TO: Mercedes-Benz Dealer Principals, General Managers, Sales Managers, Service Managers, Parts Managers	FROM: Gregory Gunther, Senior Manager, Vehicle Compliance and Analysis, Engineering Services
RE: Recall Campaign Launch Notification Replace Mounting Brackets in Roof MY23 EQS (296 platform)	DATE: January 24, 2025

Recall Campaign Bulletin

Campaign No. 2025010005, January 2025

Replace Mounting Brackets in Roof

Figure 4

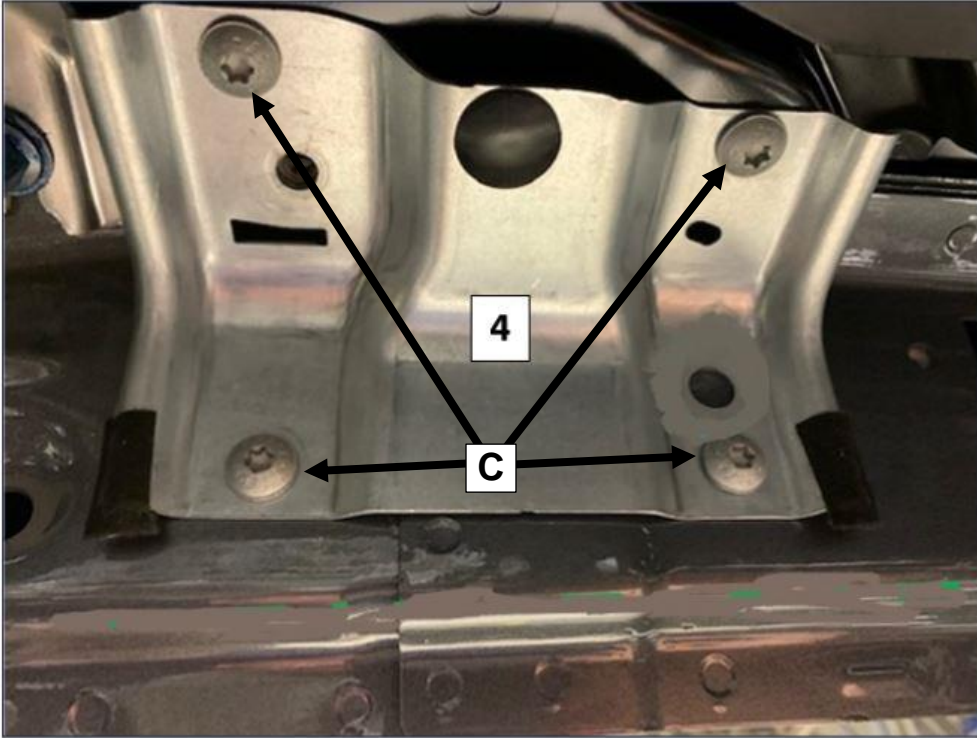
5. Replace mounting bracket (**Figure 4, 4**) on left and right B-pillar.

i To do so, unscrew mounting bracket screws (**Figure 4, C**) on left and right B-pillar (**Figure 4, 4**).

Nm Observe tightening torque of screws: **8 Nm**.
